ZONING MAP CHANGE STAFF REPORT

Owner / Applicant: Gabriel Southwest LLC

Site Location: 9500 - 9700 blocks Brewer Boulevard Acreage: 19.001

To: Planned Development for all uses in "D" High Density Multifamily plus detached

Scale: 1"=80' January, 2021 SEI Job No. 20-252

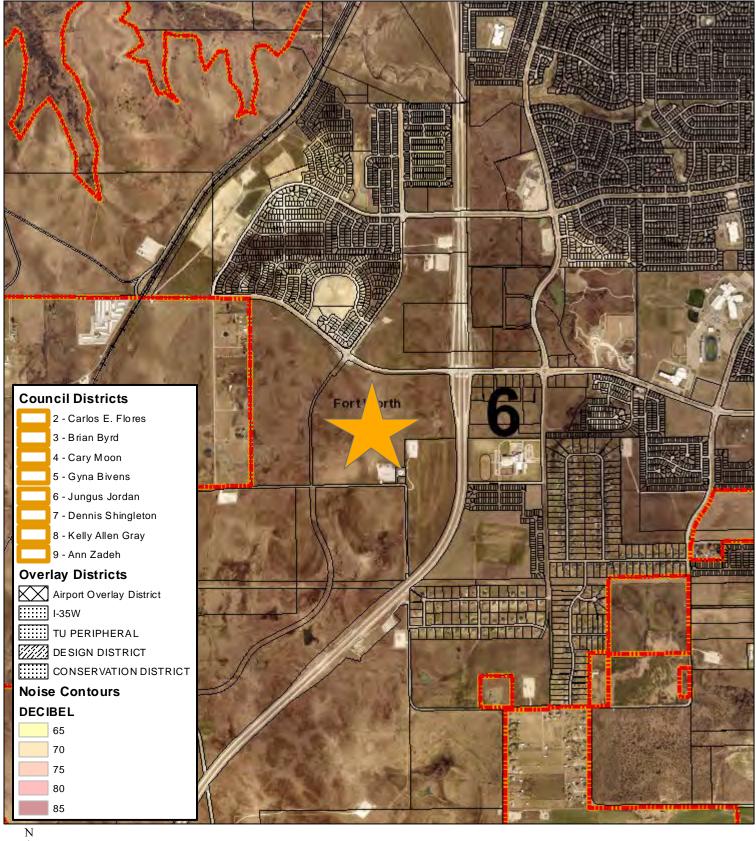
The site plan as submitted is not in general compliance with the Zoning Ordinance regulations.

- Site has fencing placed between the buildings and street. (requires Development Regulation Standard)
 - a. Due to the similar nature of detached multifamily to single family developments, staff does not have an issue with the placement of fencing between the building and the street.

- Site does not meet building orientation requirement. (requires Development Regulation Standard)
 - a. A majority of the buildings have the longer side facing the street. Additionally, the placement of a fence between the building and the street lessens the importance of this requirement.

- 3. Site does not meet required setbacks of front or corner yards. *(requires Development Regulation Standard*)
 - The bulk and height of the proposed buildings are smaller than those seen in typical multifamily developments. The setbacks are similar to those of a single family development

- 4. Applicant is requesting a waiver to the MFD Submittal. *(requires Development Regulation Standard)*
 - a. Due to the unique nature of detached multifamily developments, staff does not feel that the MFD submittal is necessary for development.
